New bulb in the roof sign illumination

Applicable to vehicles with roof sign illumination except CR19T.

Fig. 1. The old reflectors.

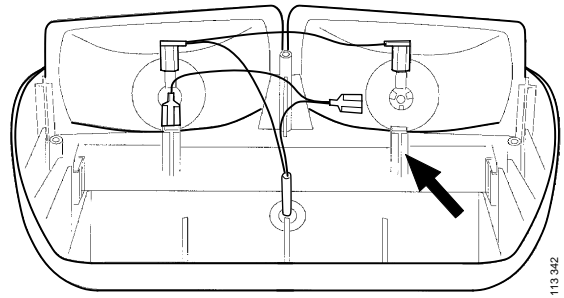
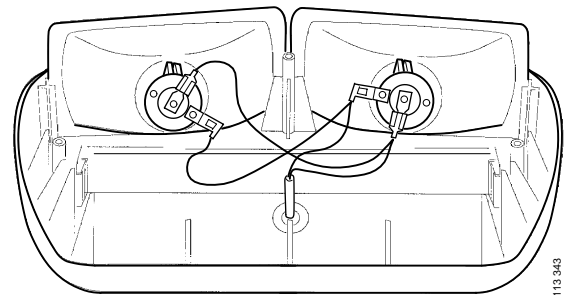
It has been reported that the roof sign illumination bulb has a short service life.

The existing bulb is replaced with a new standard bulb 21 W HD (Heavy duty).

When replacing the old bulb with bulb 21 W HD (Heavy duty), the roof sign illumination reflector must also be replaced.

Note: The plastic retainers must be removed in order to clear enough space for the new reflectors. See illustration 1. The easiest way to do this is with cutting pliers.

1. Disconnect the negative cable from the battery.
2. Open the roof sign illumination and disconnect the cables.
3. Remove the reflectors and the sheets for positive supply from the plastic retainers.

4. Fit the new reflectors with the new bulbs and connect the cables.
5. Reassemble the roof sign illumination.
6. Reconnect the negative cable to the battery.
